CITY PLANNING COMMISSION

- APPLICATION:
- A. Negative Declaration
 - B. Plan Review of three warehouse/office buildings totaling 174,888 square feet on 9.3+ vacant acres in the Light Industrial-Review (M-1(S)-R) zone
 - C. Lot Line Adjustment to relocate the common property line of 4 lots totaling 19.24+ vacant acres in the M-1(S)-R zone

LOCATION: Southeast corner of Raley Boulevard and Santa Ana Avenue

PROJECT EVALUATION: Staff has the following comments:

STAFF MODIFIED SITE PLAN

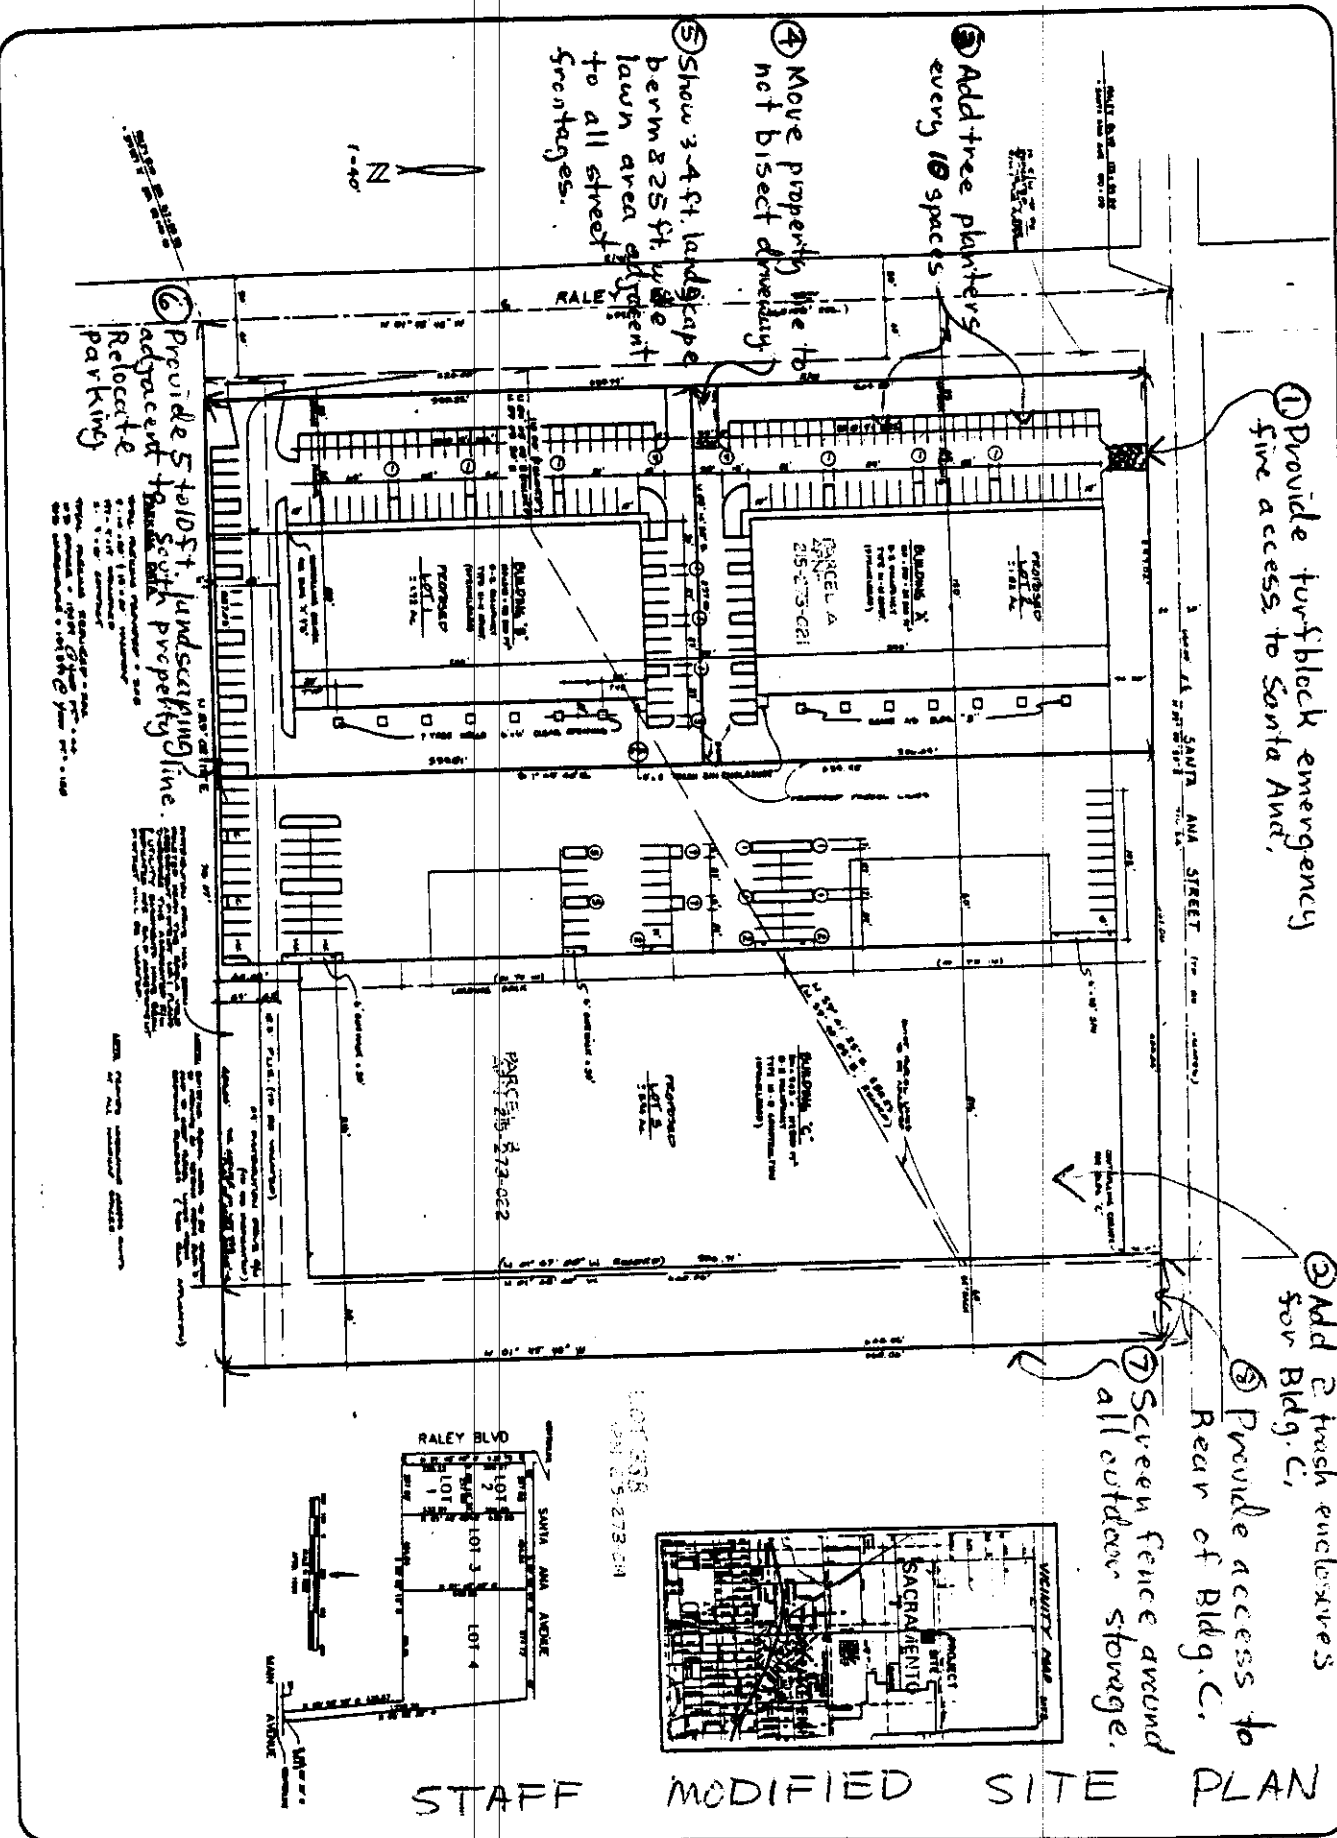
Since the applicant shows 208 spaces overall for the development, adequate parking is provided for a mix of 10% office and 90% warehouse. Staff is concerned that a deficit of parking for Building C of 70 spaces shows. Reciprocal parking and access agreements and easements are necessary to provide required parking off-site. Planning Division

Parking is provided along the south property line of Parcels B and C. Staff notes that the south elevations of the buildings could be better screened if a 5 to 10 foot wide landscape strip be provided with evergreen trees planted on 20 foot centers with shrubbery. Since the screening along

Buildings A and B each show one trash enclosure located adjacent to the east building elevation. No enclosure is shown for Building C. Due to the size of Building C, staff recommends a minimum of two trash enclosures for Building C be shown on the revised site plan and complying with City Trash Enclosure Guidelines. No unenclosed dumpster units will be allowed.

Staff notes that Building A at the southeast corner of Railey and Santa Ana has a long, 360 foot row of parking with no access onto Santa Ana Avenue. For a similar situation for Sacramento Security Park, the Fire Marshal's Office requested secondary emergency access. Staff recommends use of a emergency access. Staff recommends use of a paverstone at the northern part of the Building A parking lot through the landscape setback area. The site pian shall be revised to show paverstone or similar treatment capable of carrying fire equipment.

1. The applicant shall prepare a revised site plan, detailed landscaping and irrigation plans reflecting comments in Section 3 for review and approval by the Planning Director prior to issuance of building permits.

- j. Building permits shall not be issued until Certificate of Compliance for the lot line adjustment is recorded.
11. Emergency access shall be provided to the satisfaction of the Fire Marshal's Office and the Planning Director for all lots. Lot A shall have emergency access onto Santa Ana Avenue at the end of the Rows of parking using turf block over the 25 foot landscape area.

12. Two trash enclosures are to be provided for Building C designed to City standards.
 13. No outdoor storage is allowed unless screened. Height of stored materials shall not exceed the fence height.

14. Each proposed lot shall provide adequate parking for the proposed tenants. A revised detailed parking analysis is to be provided showing required parking on each lot based upon use.

RALEY BLVD. BUILDING 'A'
ELEVATIONS
 PANATTON DEVELOPMENT CO. CITY OF SACRAMENTO, CA.

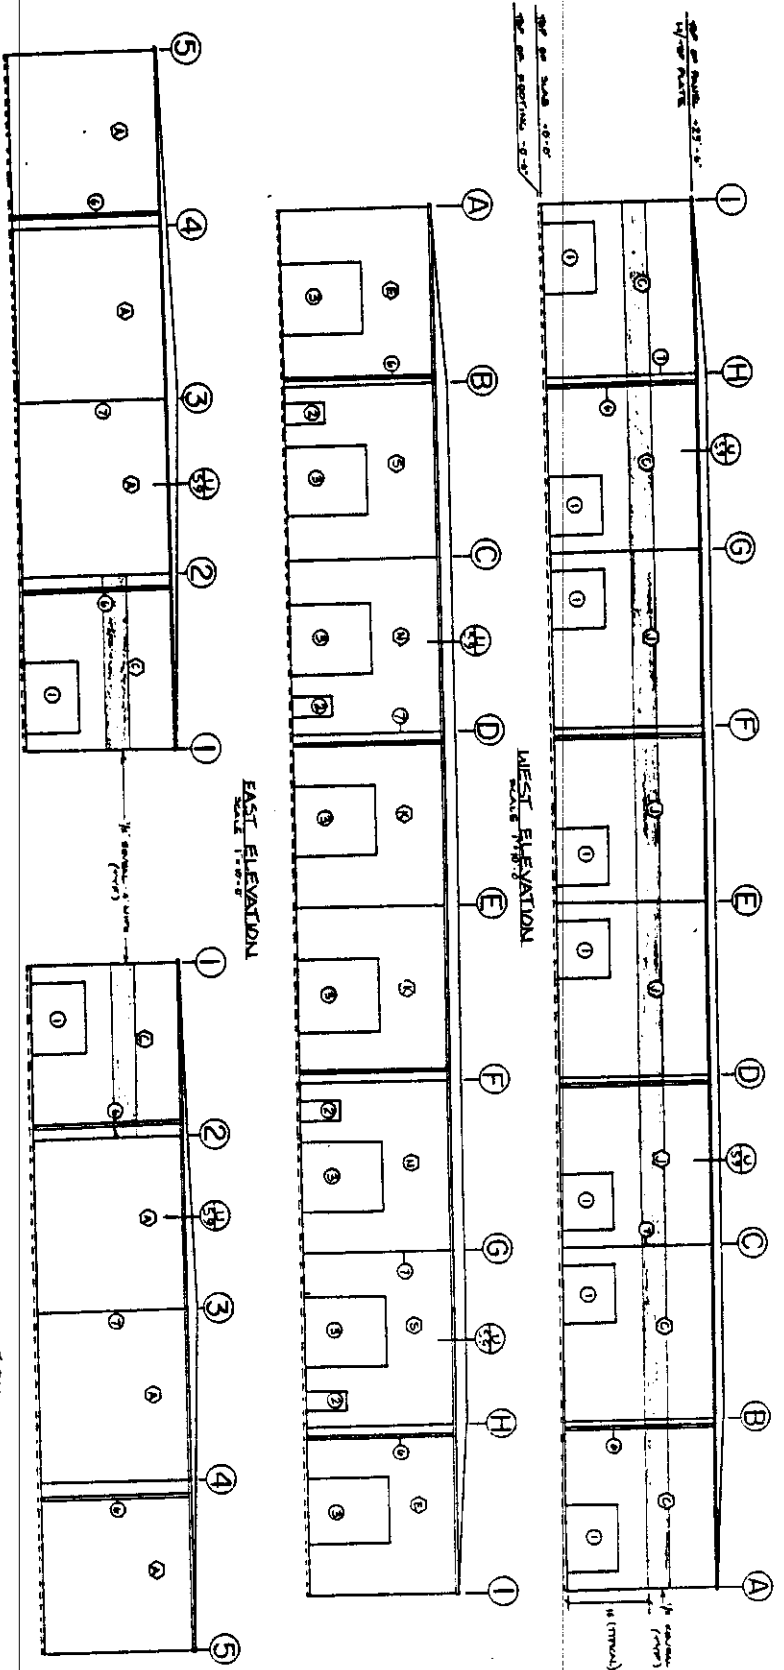
Regarding the store front window system, the applicant has agreed to modify the front elevations of buildings A and B to reflect more variety through the use of four, four inch wide, one inch deep reveal lines placed equidistant along the top half of the wall sections and wrapped around the ends of the building. The addition of columns and recessing the window system into the building is proposed. Staff recommends that these revisions to the elevations be reviewed and approved by the City Design Review Coordinator prior to issuance of building permits.

2. The applicant shall revise the exterior elevations to the satisfaction of the City's Design Review Coordinator and Planning Director. All proposed colors are to be included in the revised elevations.
